**DRB RECOMMENDATION PACKAGE**

## PUBLIC STORAGE

1200 SOUTH DEARBORN STREET, SEATTLE, WA

**DPD PROJECT #:** 3017092

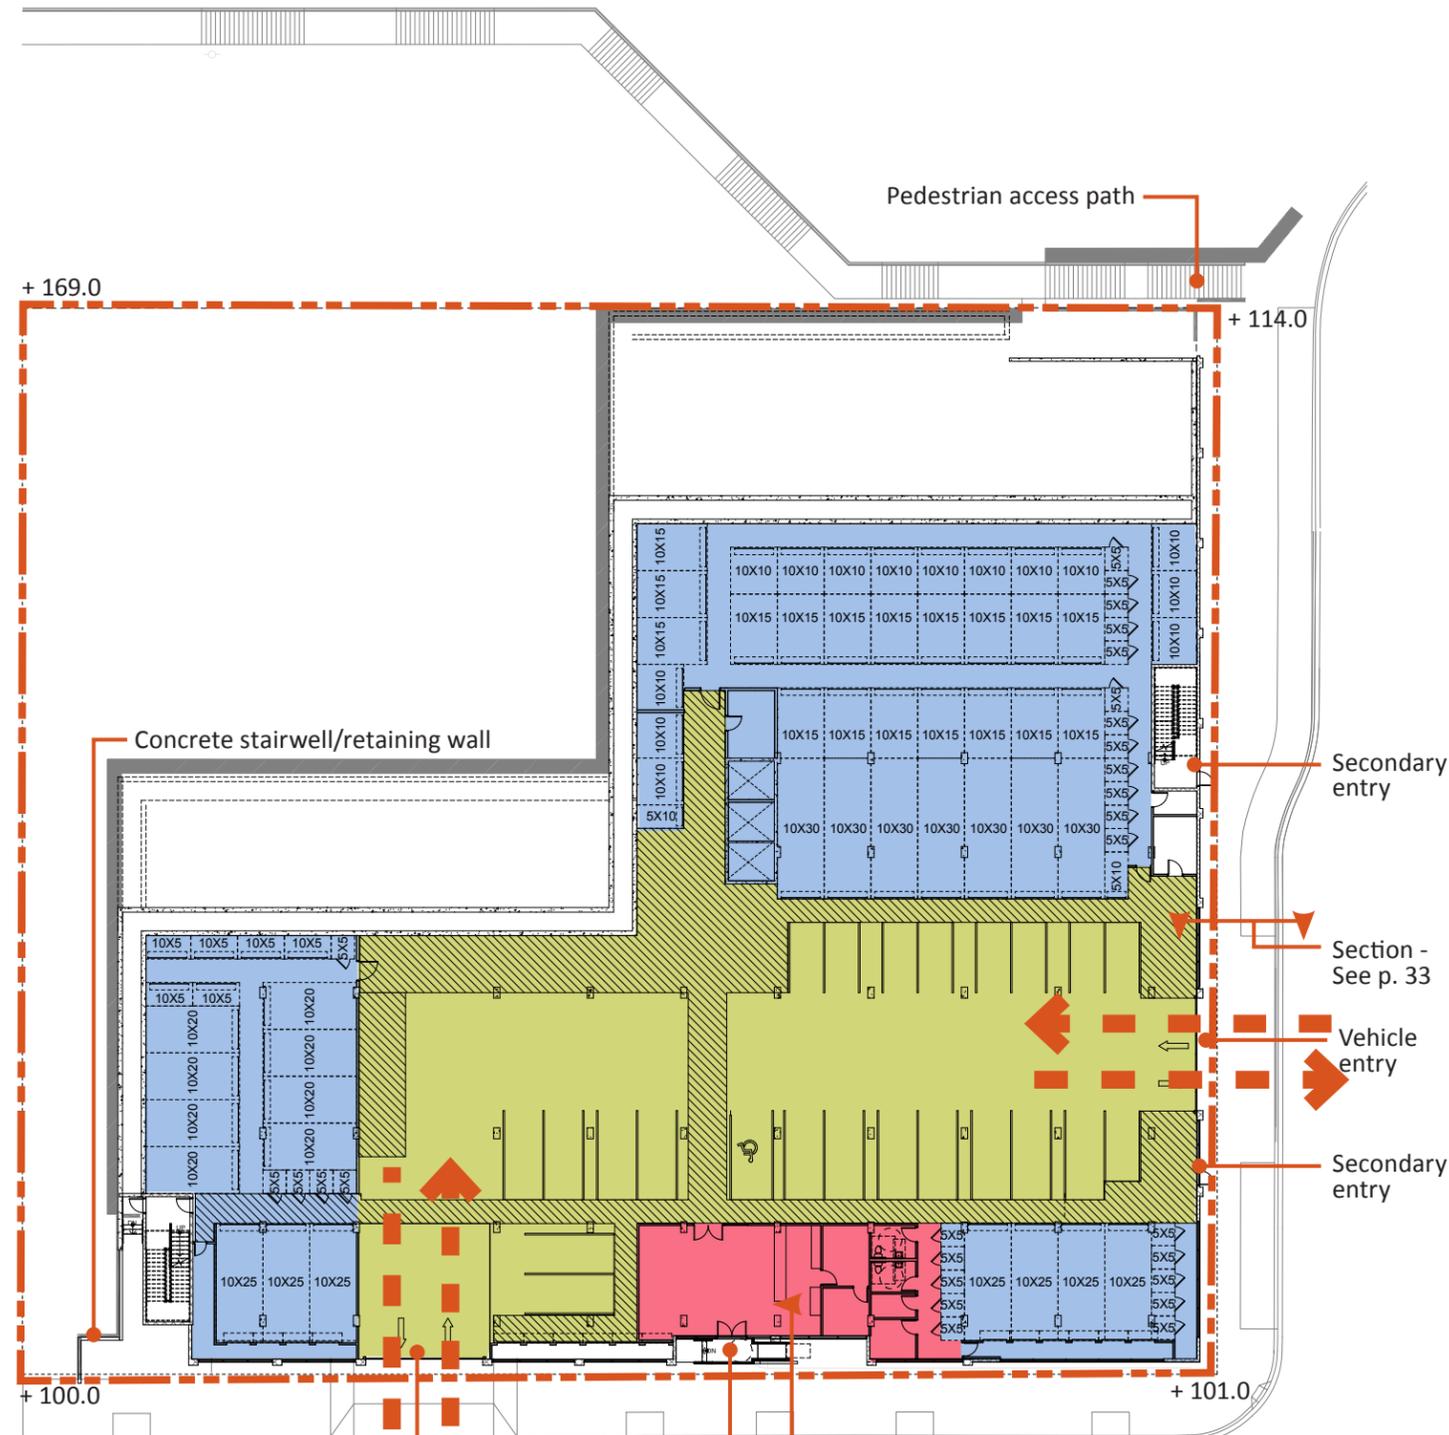
**June 10, 2014: The Board recommended the use of landscaping on-site to provide visual depth and interest which will enhance the open space. The Board asked for a conceptual landscape plan at the Second Early Design Guidance Meeting.**

**July 22, 2014: The Board discussed the conceptual landscape plan and street trees. The Board agreed that there may be opportunity along South Dearborn Street to include landscaping in addition to the street trees, and recommended further consideration and refinement. The Board requested a landscape plan be presented at the Recommendation Meeting. This landscape plan shall include all required right-of-way dimensions for South Dearborn Street and 13th Avenue South. Additionally, the Board discussed the importance of the treatment of the roof, and suggested consideration of a green roof element.**

[BCRA Response: The open space on the site will be landscaped with native plantings such as those shown on the Conceptual Landscape Palette on page 32 of the updated EDG package. Street trees will line the sidewalk along South Dearborn Street and 13th Ave South. The open space will be used as part of the storm water management system and as a visual buffer.](#)

[BCRA Response: The concept of a green roof has been explored and was determined to not be a feasible option for this facility. The landscaping along the street frontages of South Dearborn Street and 13th Ave South has been thoughtfully designed with the pedestrian and the area in mind. The proposed landscape plan will enhance the pedestrian environment and improve the streetscape for passersby. A landscape plan has been included in this packet and can be found on page 23.](#)

[The dimensions of the rights-of-ways of South Dearborn Street and 13th Ave South have been added to the landscape plan.](#)

FLOOR 1

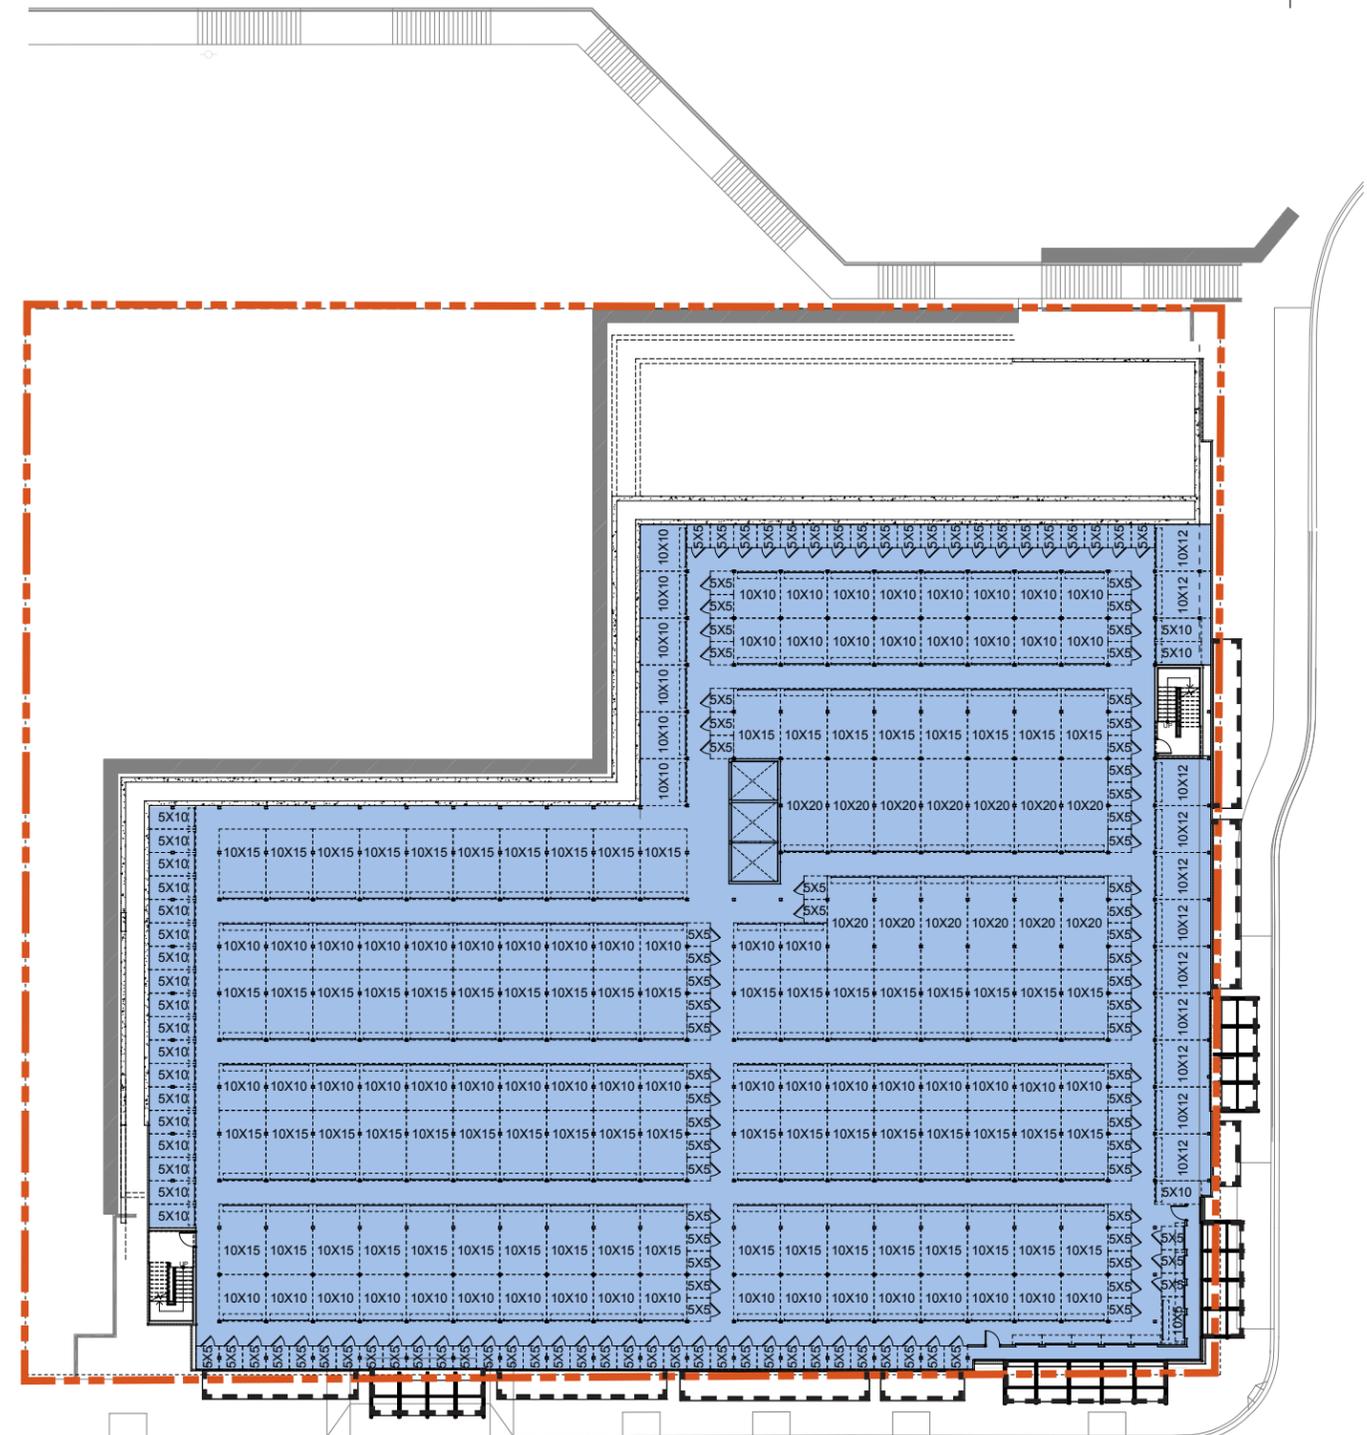
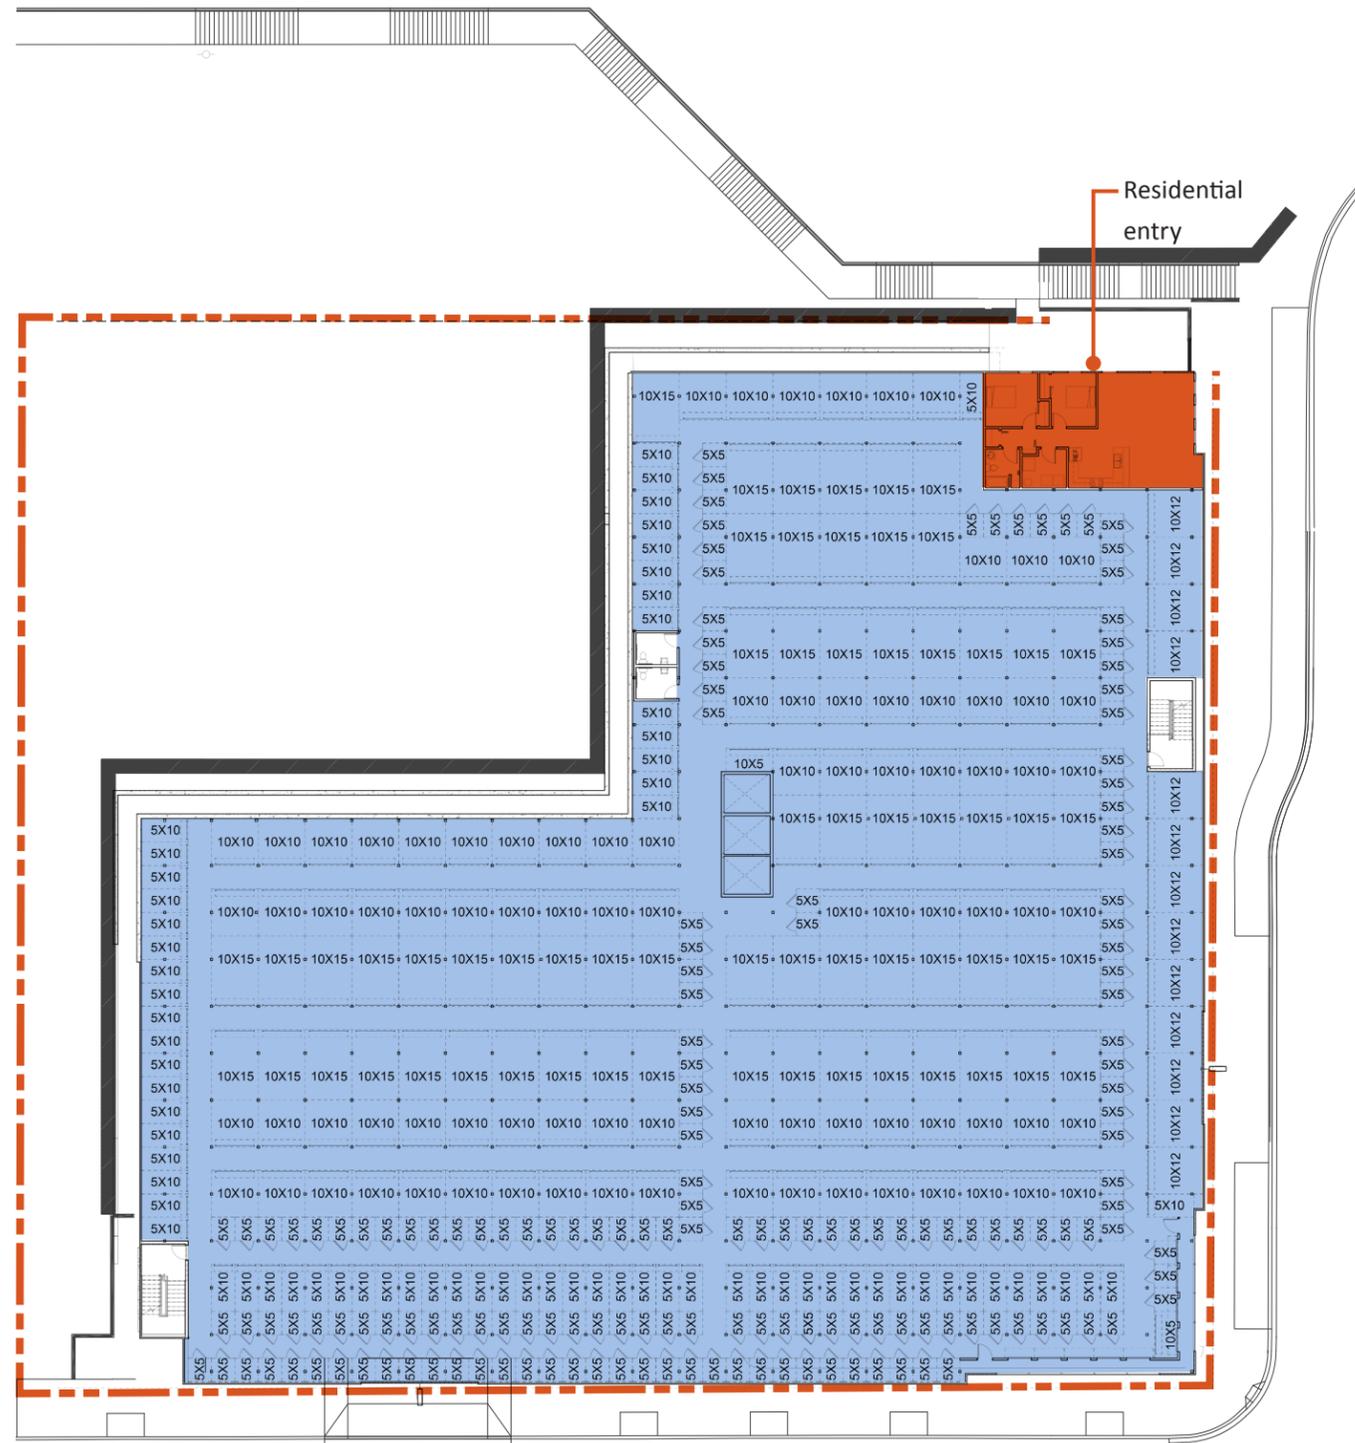
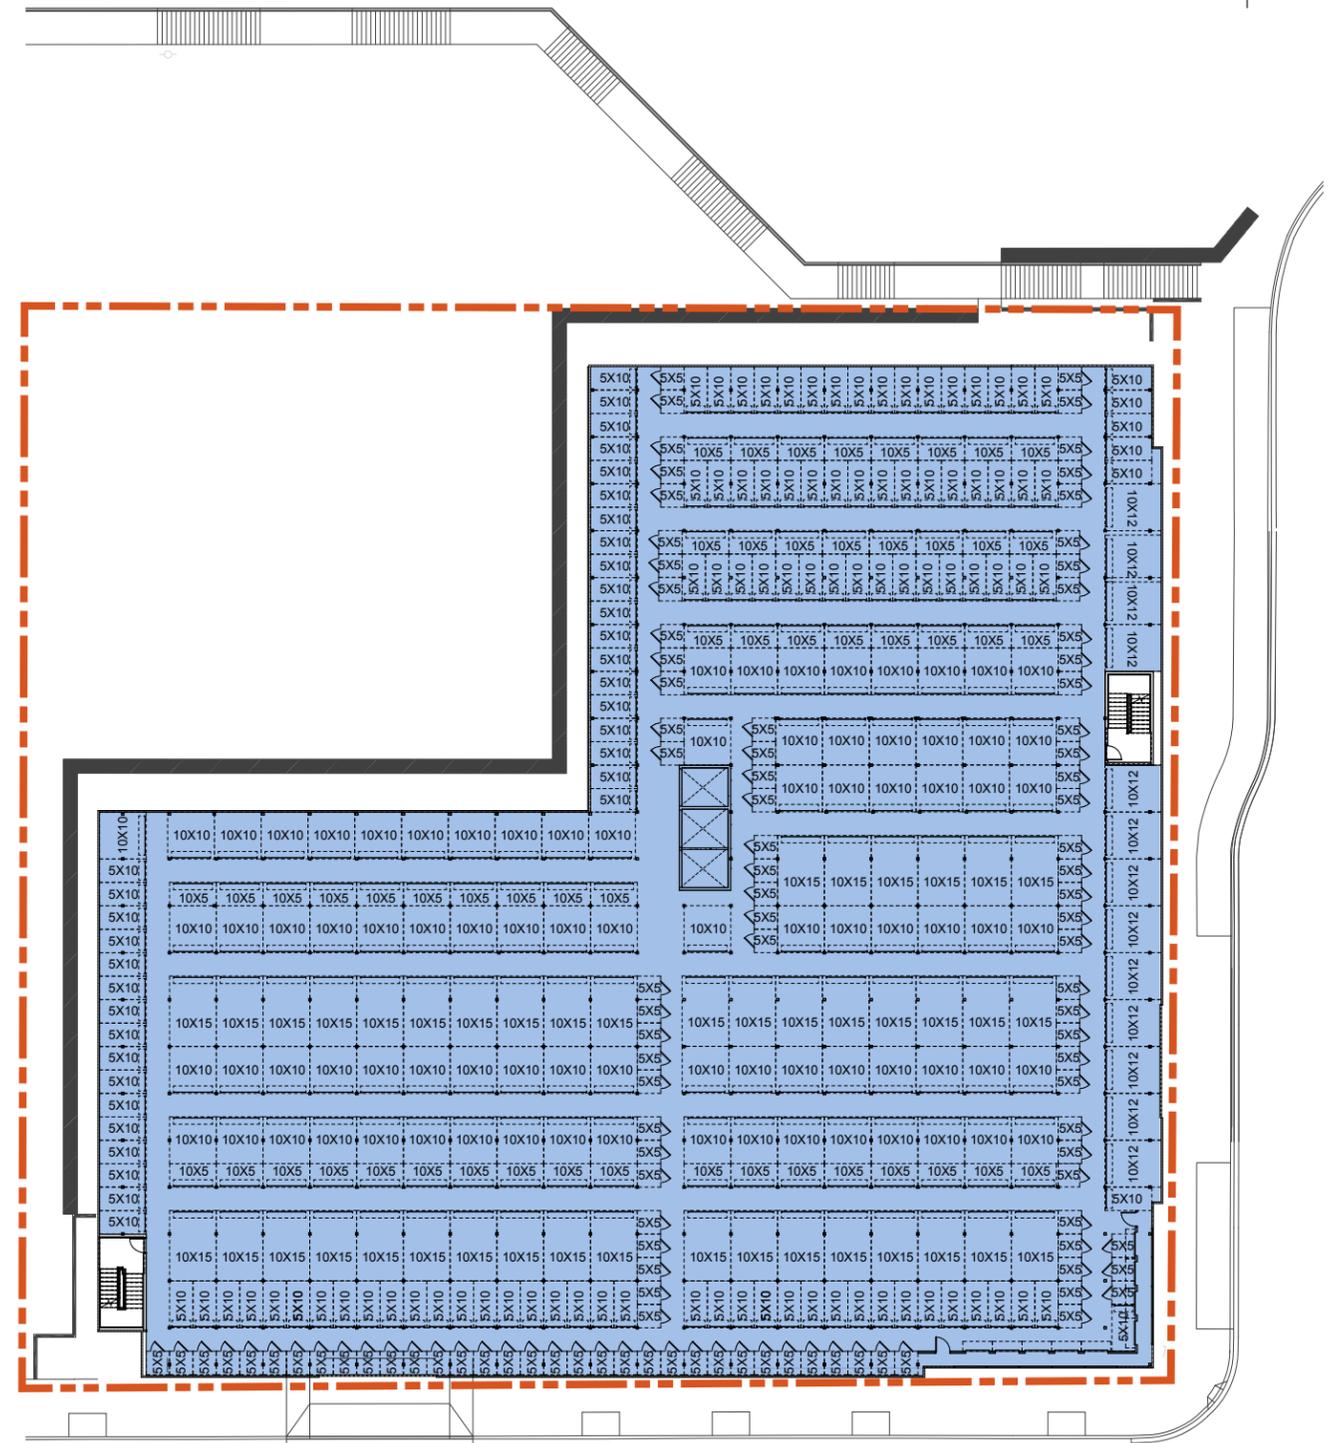
**connection to the interior of the space that will communicate forms and uses. This display area will be lit at night. The Board supported these elements, and recommended consideration of adding more active display elements along South Dearborn Street and/or 13th Avenue South. The Board requested floor plans to illustrate the uses and forms that will be translated at the exterior.**

**July 22, 2014: The Board discussed the residential unit and agreed that its use is accessory, and its translation to the exterior is inconsequential. The active display described for the corner element was supported, and the Board recommended consideration of adding other opportunities for active display along South Dearborn Street and/or 13th Avenue South. The Board requested floor plans be presented at the Recommendation Meeting to illustrate the relationship between the interior and the active display elements at the exterior.**

BCRA Response: Display areas ranging in depth between 3' and 5' have been added along the South Dearborn Street facade. Floor plans have been included and can be found on pages 20 - 22.

BCRA Response: Display areas ranging in depth between 3' and 5' have been added along the South Dearborn Street façade. Floor plans have been included and can be found on pages 20 - 22.
